Comprehensive Development Plan Fahey Fields Fitchburg, WI

Application: CDP-2045-14A / PP-2054-15A
Property Address: TBD
Property Location: Lot 2 CSM 9896
Review Date: June 29, 2015
Planning Staff Review #1

**Fahey Fields Plat
CDP & Preliminary Plat
Public Works Review #3**

PHASE MAP
FAHEY FIELDS
 CITY OF FITCHBURG, DANE COUNTY, WISCONSIN

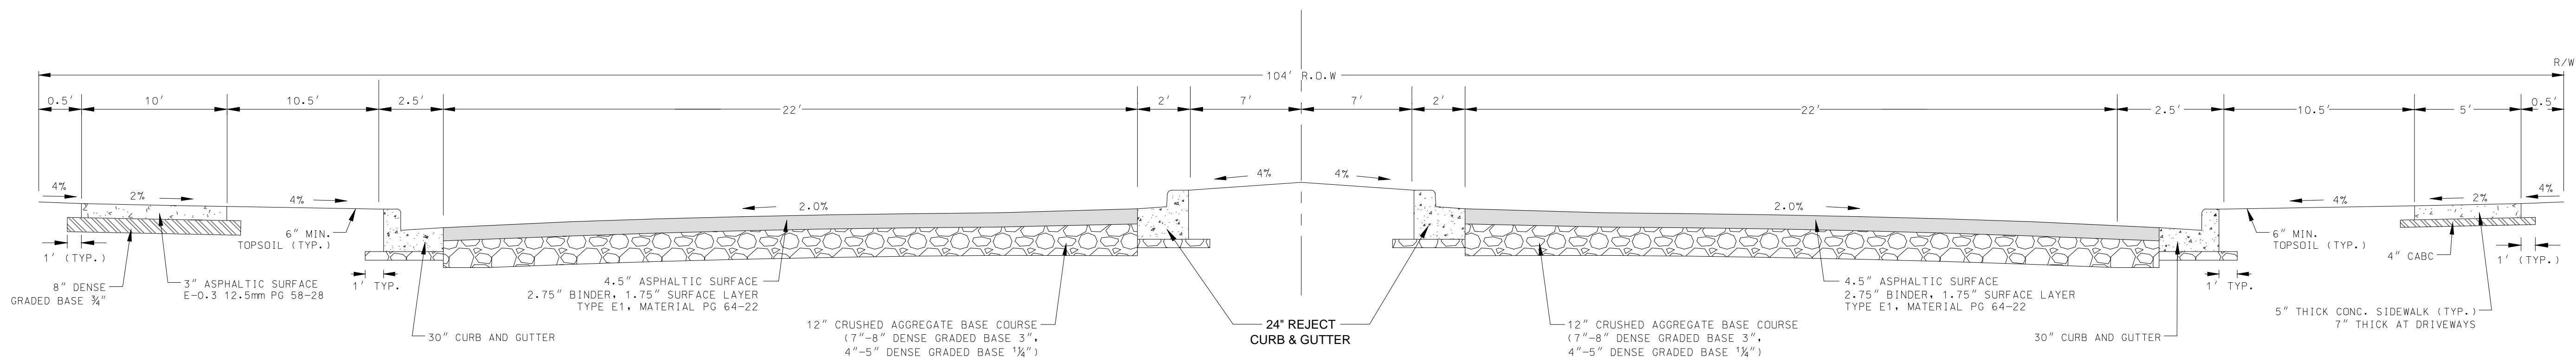
- 2.) The proposed phasing plan shows part of Outlot 7 being dedicated in Phase 1 and Phase 5. If Outlot 7 is not being dedicated in one single phase, it will need to be done as separate outlots.
Phase Map has been revised to show all of Outlot 7 being dedicated in Phase 1.
- 3.) Section 3.1 on page 2 states that there will be 124 single-family dwelling units while page 5 of the CDP document indicates that there will be 121 total single-family units. Please clarify this inconsistency and update document to reflect accurate number of units.
CDP has been revised to be consistent. 121 total single-family dwelling units are proposed.
- 4.) Park dedication and fees to be calculated at time of final platting.
